DOCUMENT TITLE  
**SERVICE NOTIFICATION WSN  
 RT-5000-40 DSP BOARD U4 VERIFICATION**

**EQUIPMENT: RT-5000**

**SERVICE NOTIFICATION NUMBER: WSN RT-5000-40**

Figure 1: Correct Waveform – Note that Channel 1's rising edge correlates to a rising edge on Channel 2.

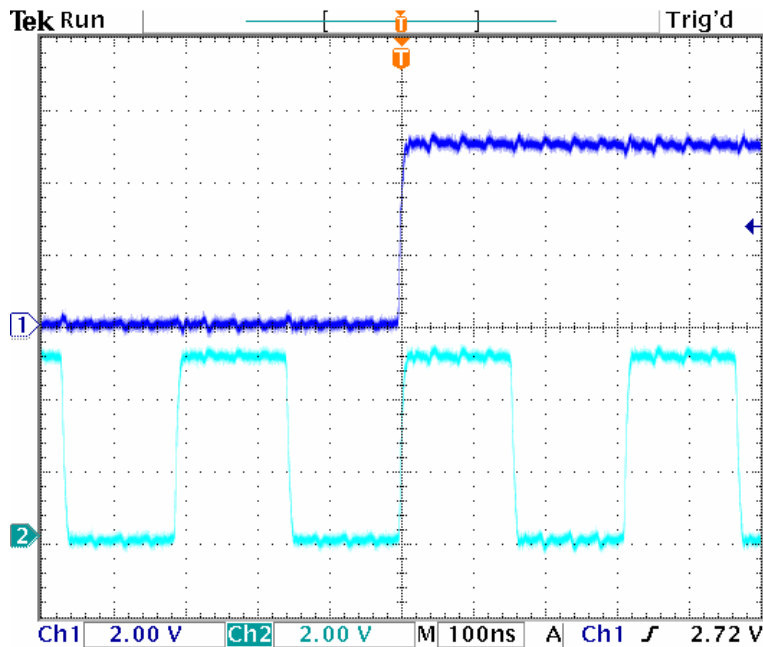
Using an oscilloscope, look at pin 14 (L/R signal) and set this as the triggered waveform, as shown on Channel 1 in Figures 1 and 2. Look at pin 15 (SCLK signal) as the secondary trace. When L/R (Pin 14) changes, it should match up with a rising edge of the SCLK (Pin 15) signal. If it does not, the part is defective and needs to be changed. Also ensure that the SCLK signal is consistent in frequency – that all periods are spaced identically and the spacing doesn't change from one period to the next.

Test U4 (PN 106-716862-02) pin 15 on the DSP module (PN 300-016260-0XXX) to ensure the clock signal is the correct polarity. If part is found to be operating incorrectly, replace with non-counterfeit part.
